**ADDENDUM
NO. 3**

September 11, 2024

**LOGANSFORT JR. HIGH SCHOOL RENOVATIONS
Logansport, IN 46947**

© GIBRALTAR DESIGN SHEET
S-201

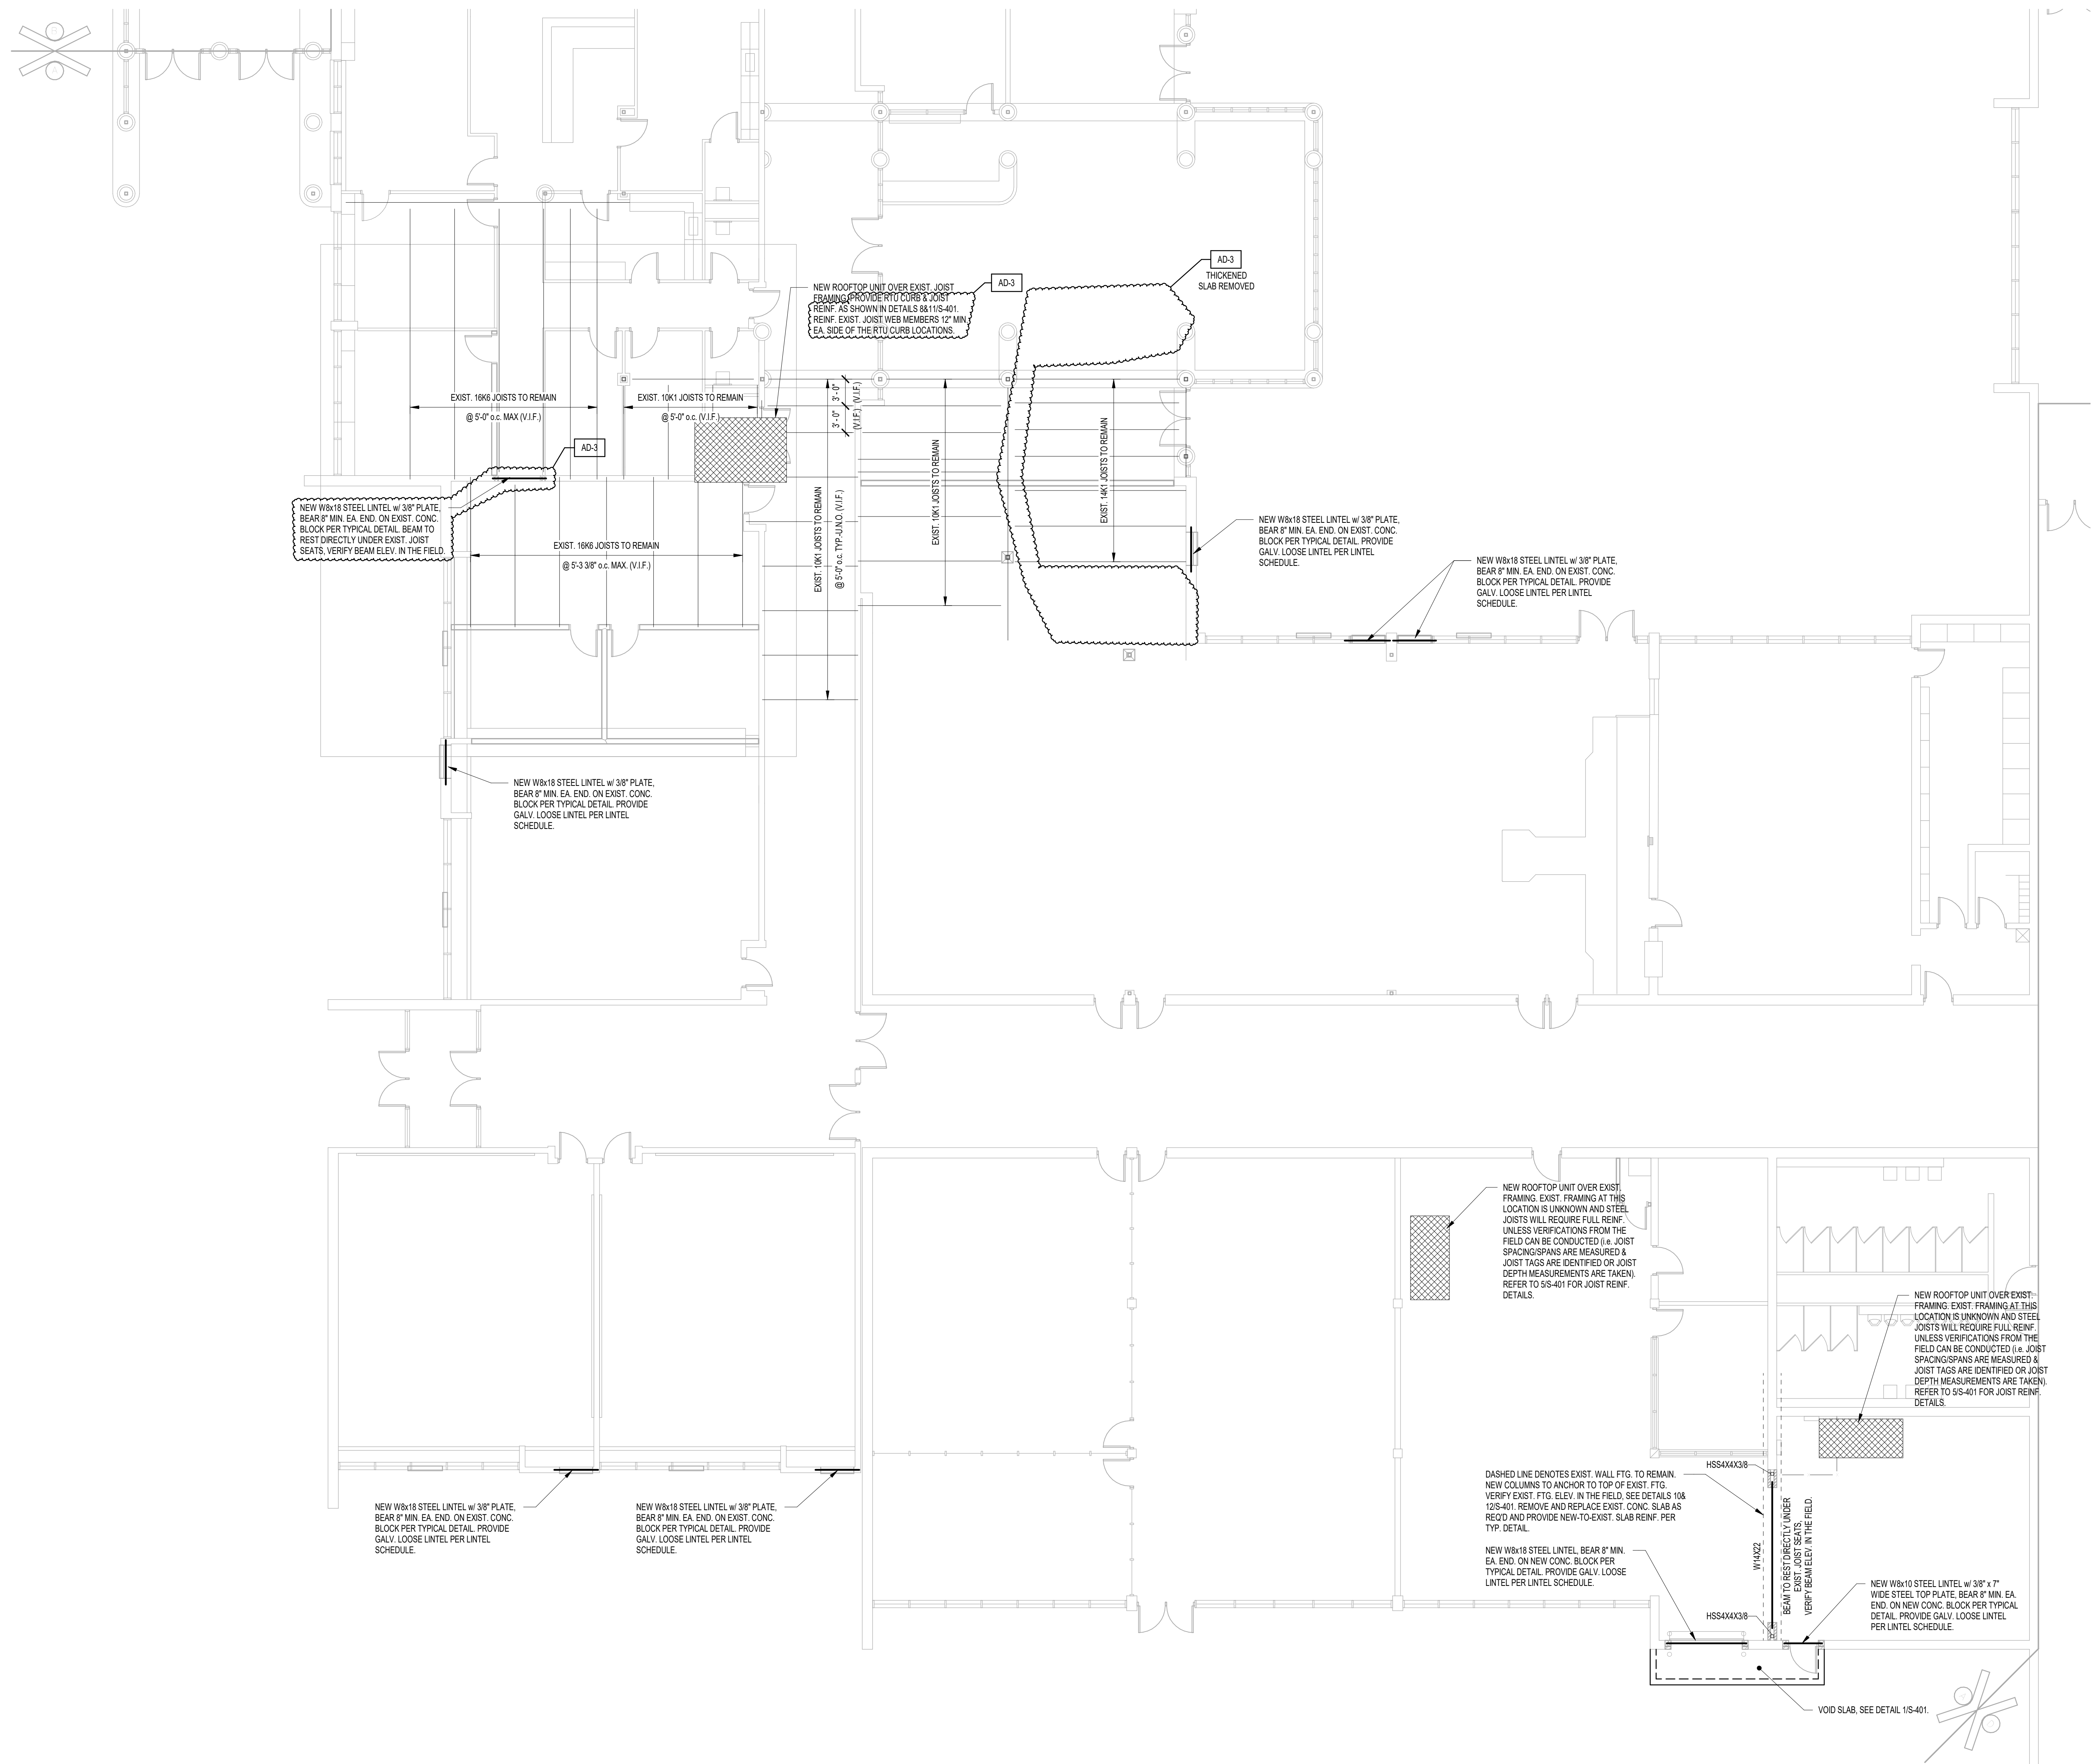
- A. New steel lintel added at Admin area wall opening.
B. Additional clarification on joist reinforcement under RTU-1 provided.
C. Thickened slab removed where 8" concrete block is being replaced by cold-formed framing.

GIBRALTAR DESIGN SHEET
S-203

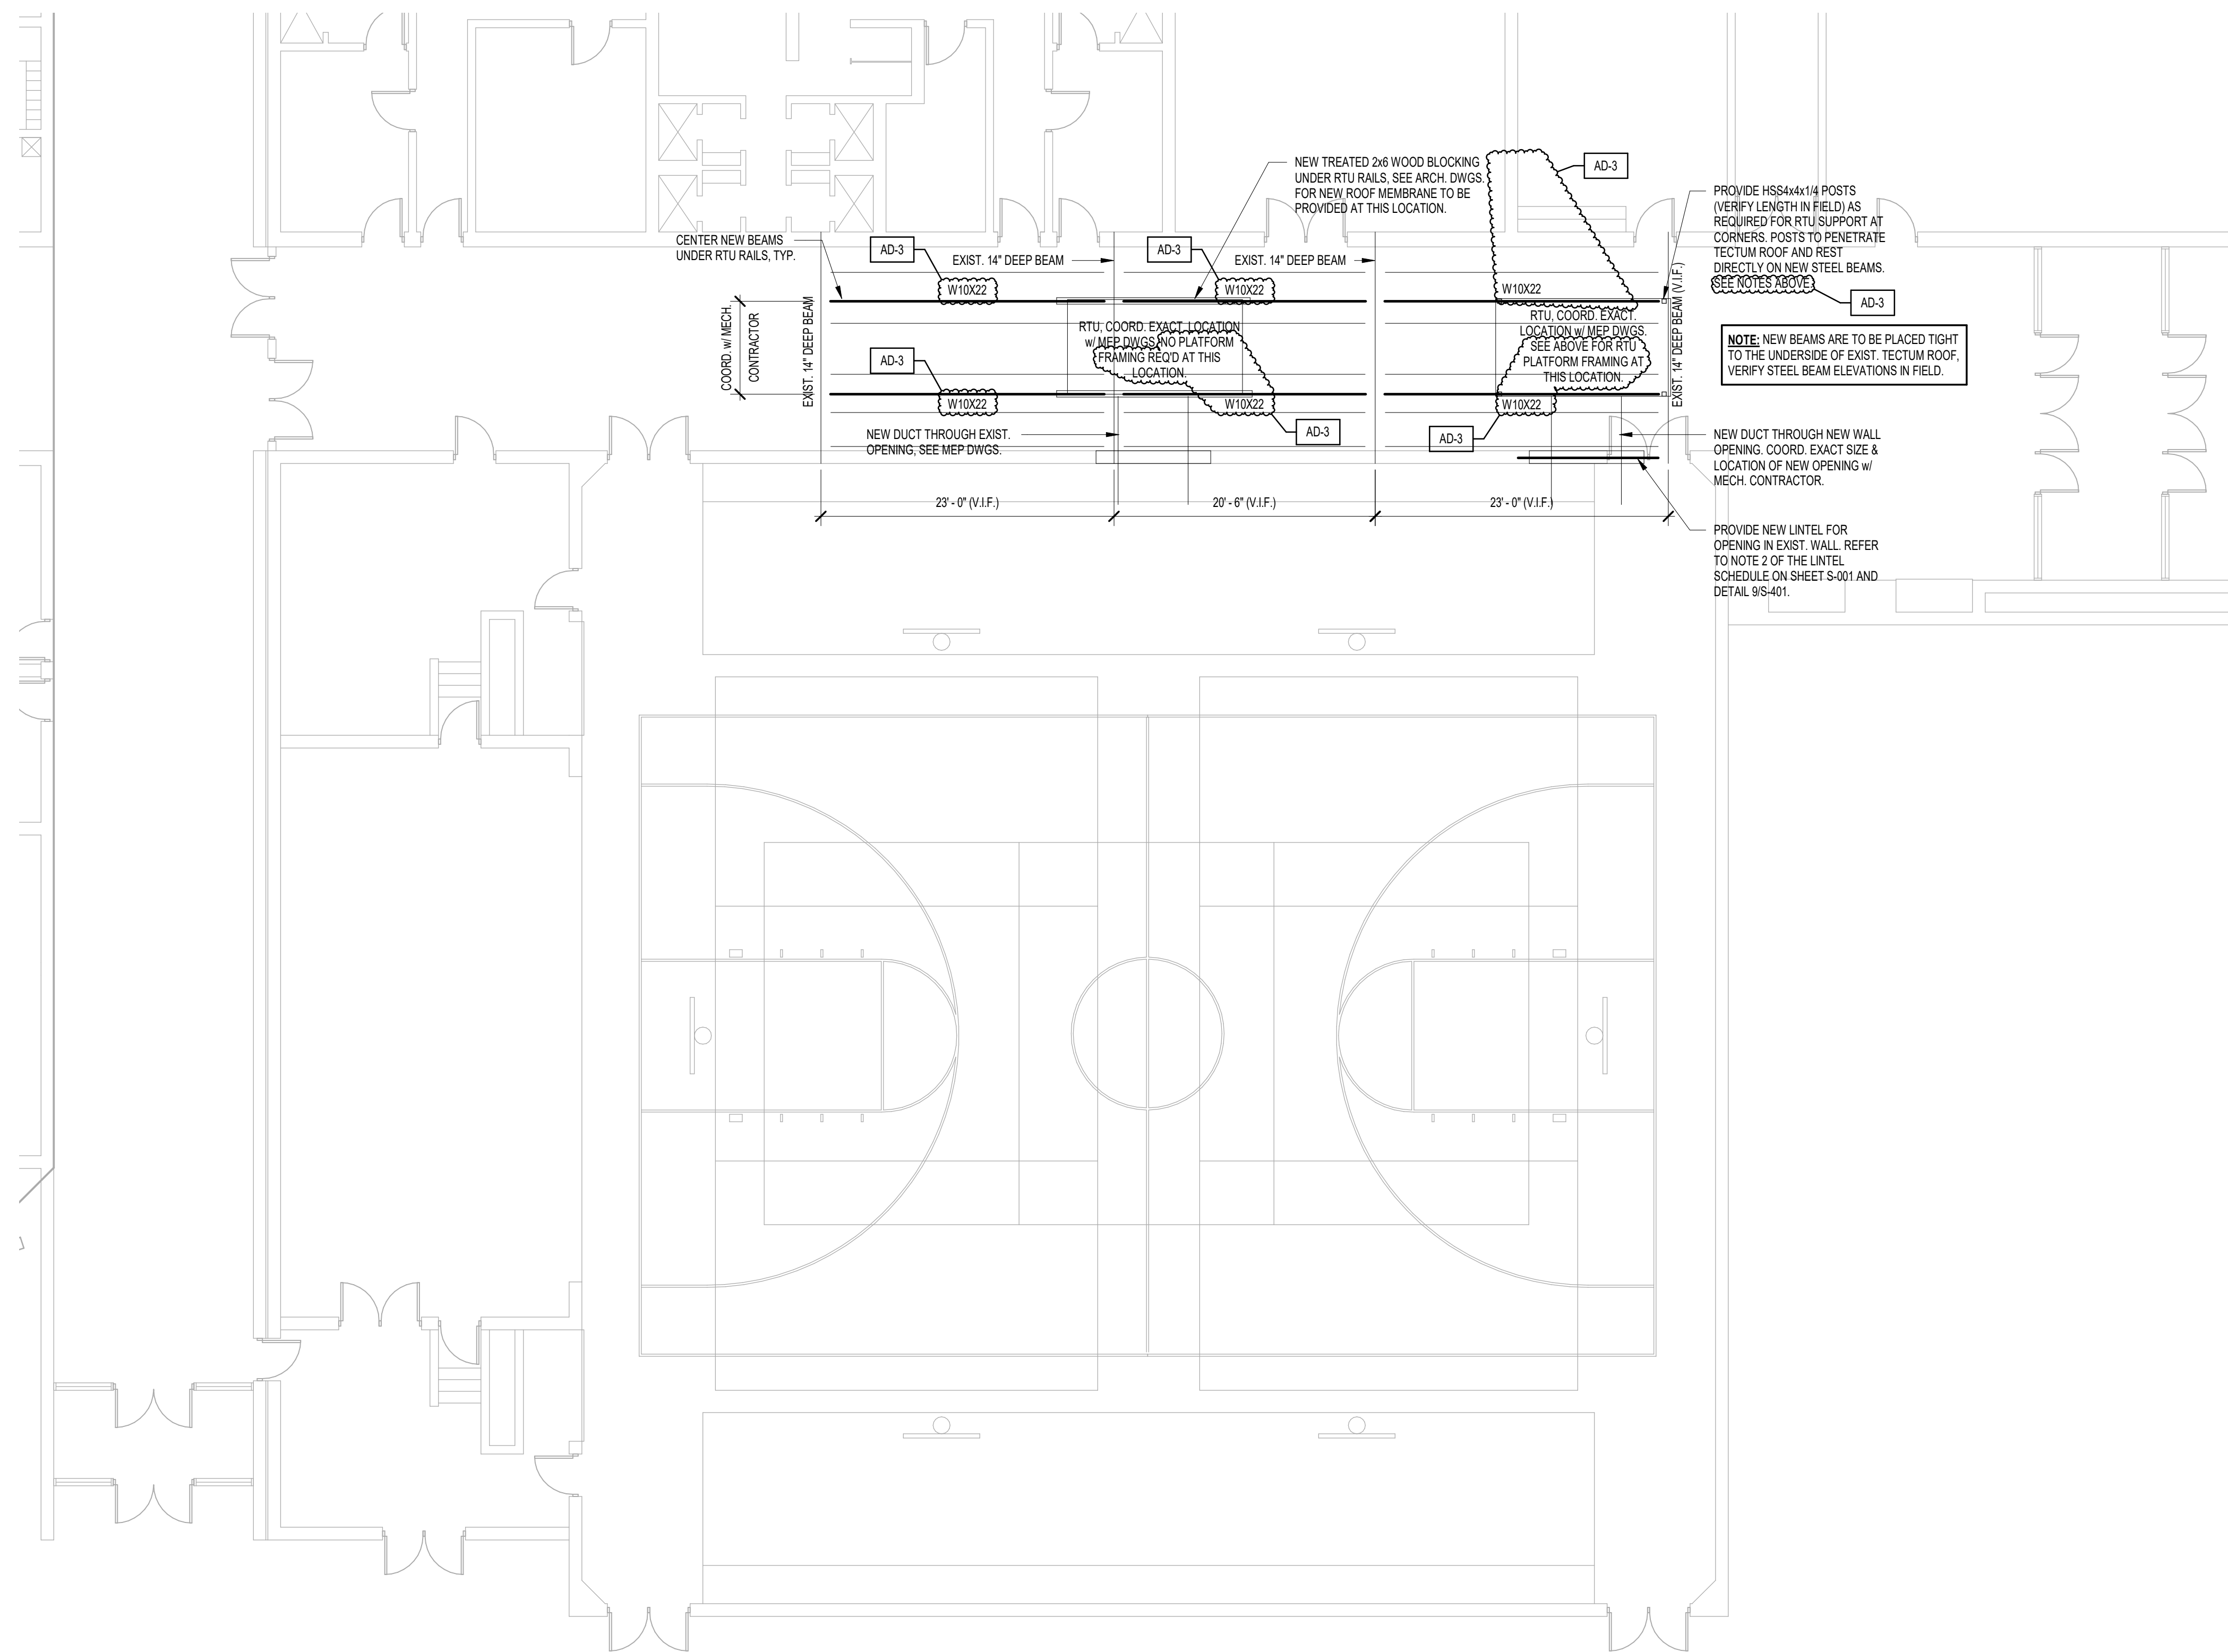
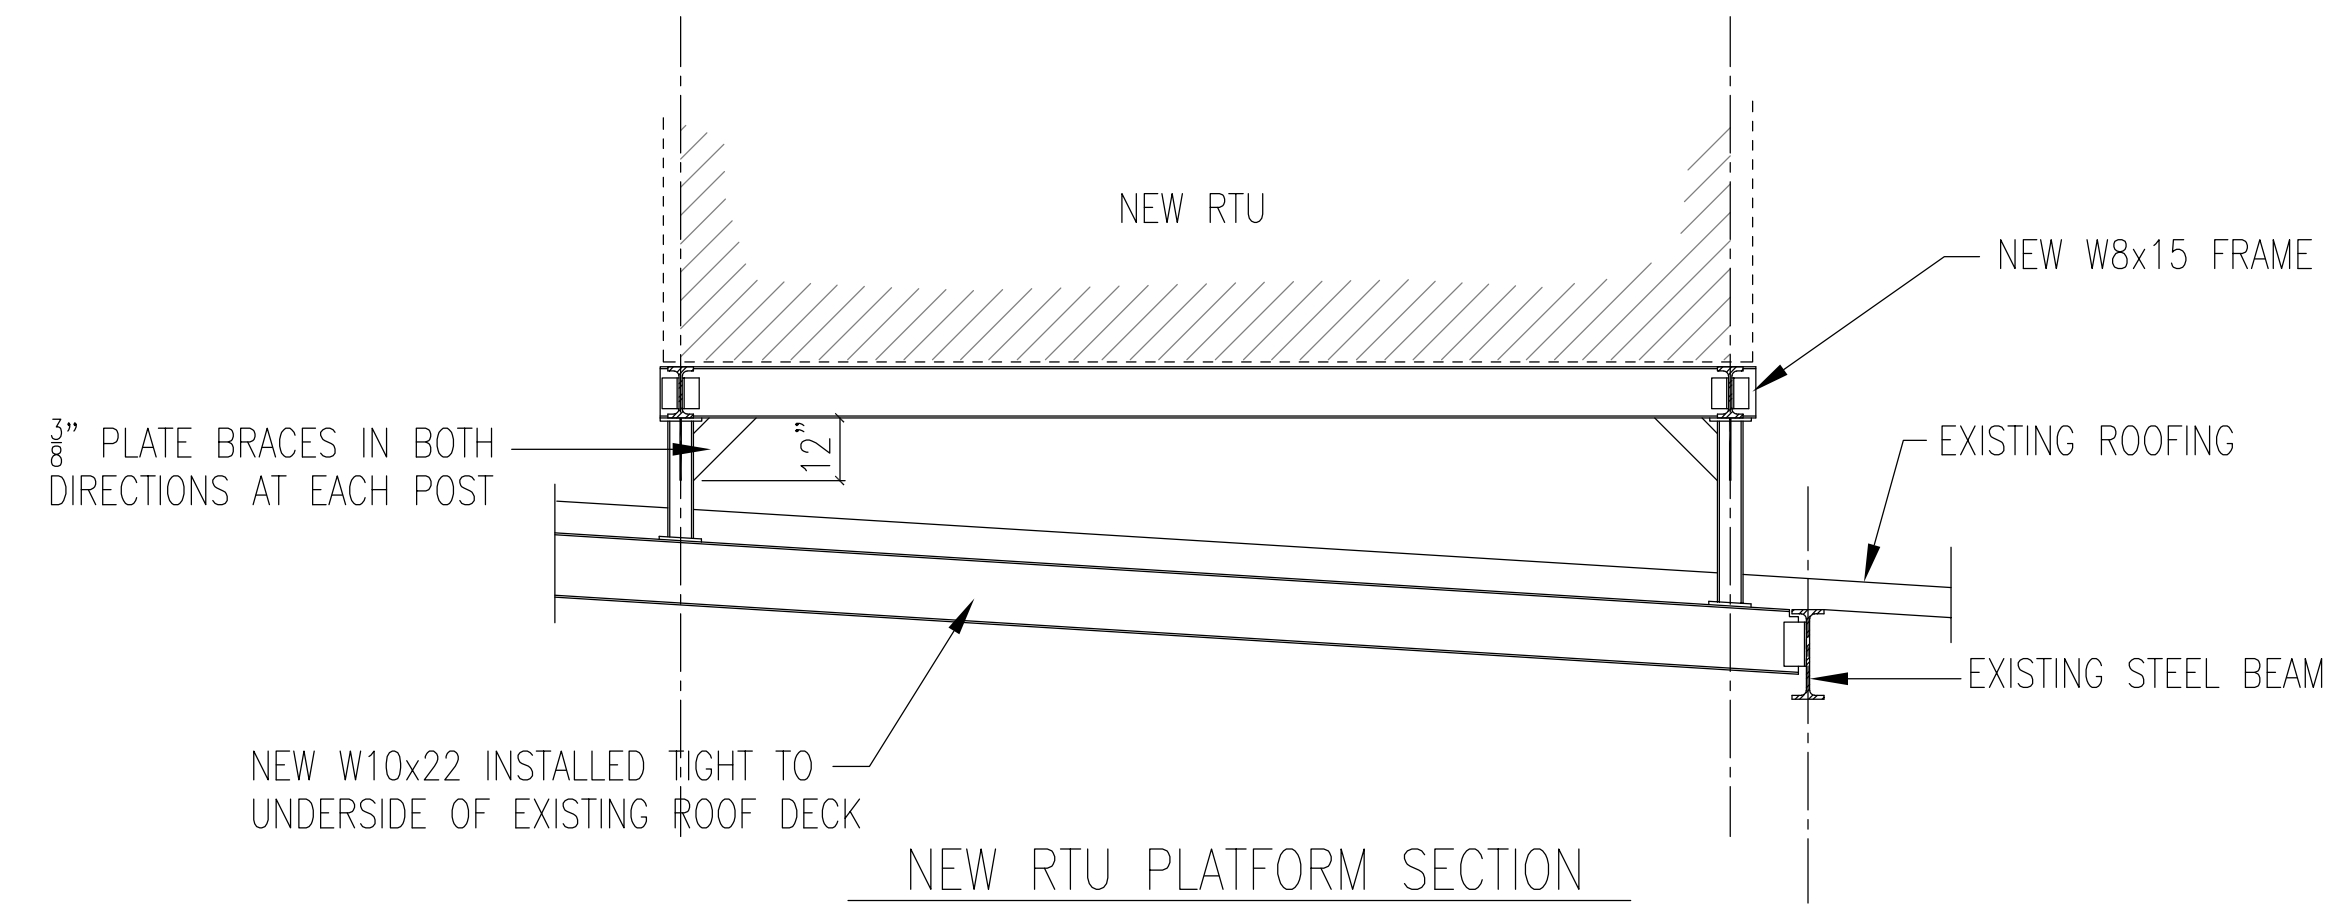
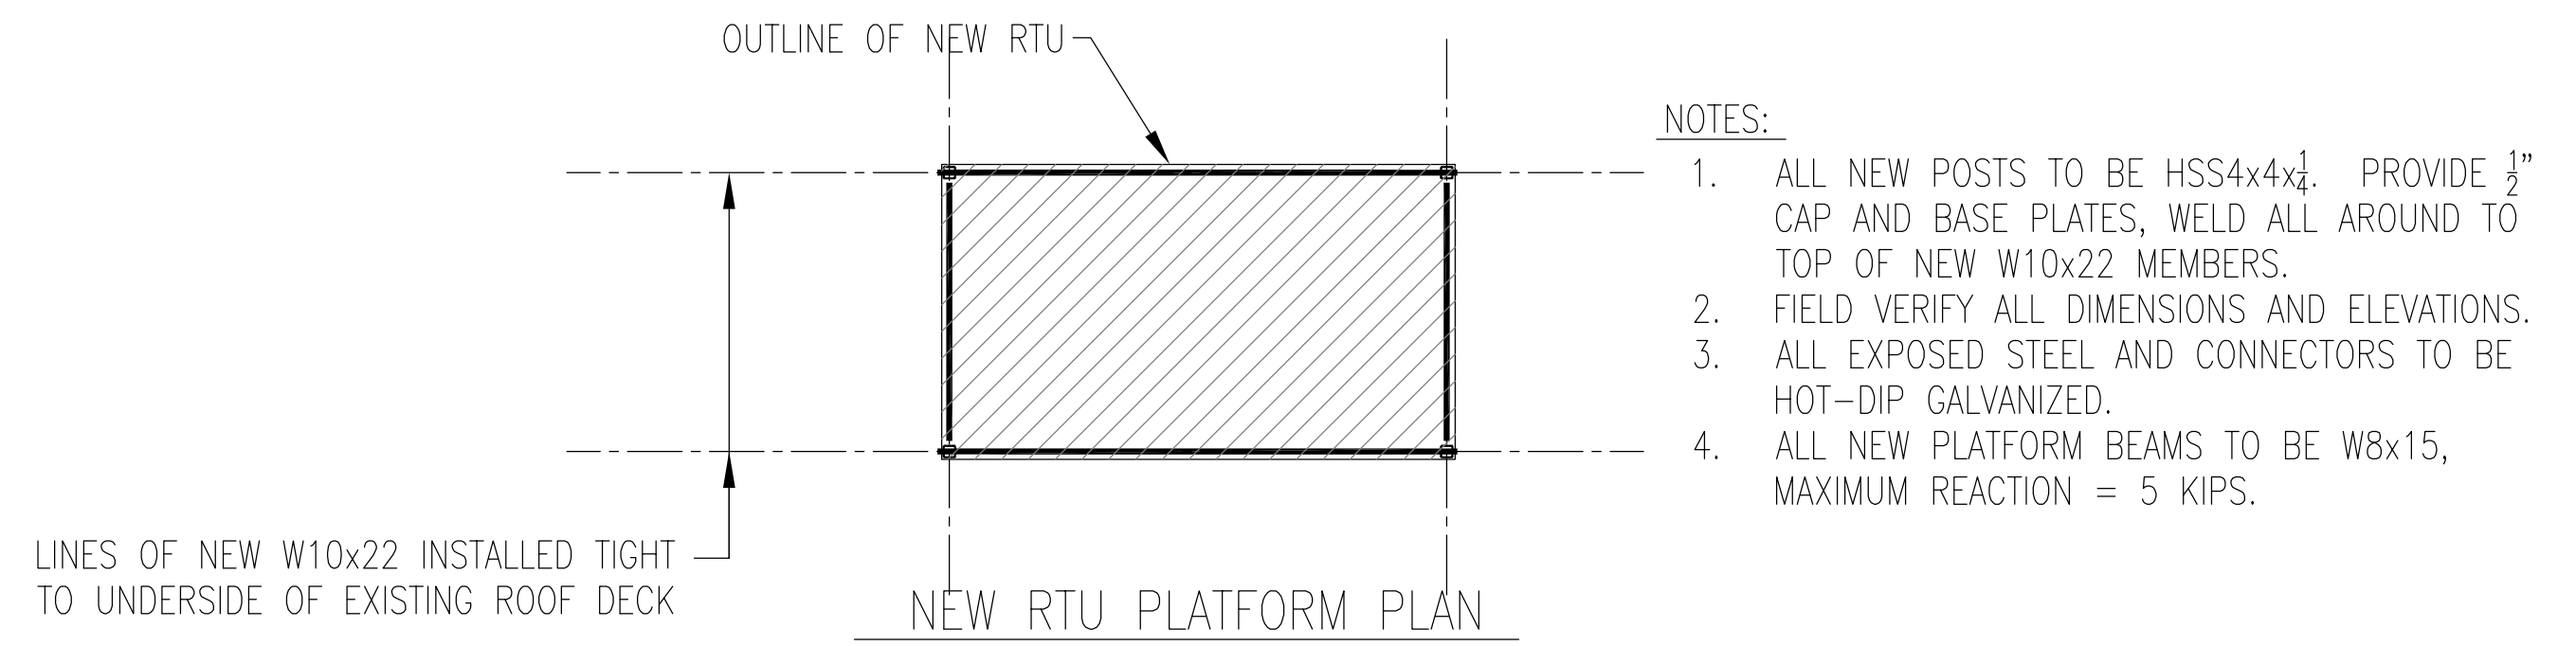
- A. Beam sizes under RTUs have been revised.
B. Details for the RETU platform have been provided.
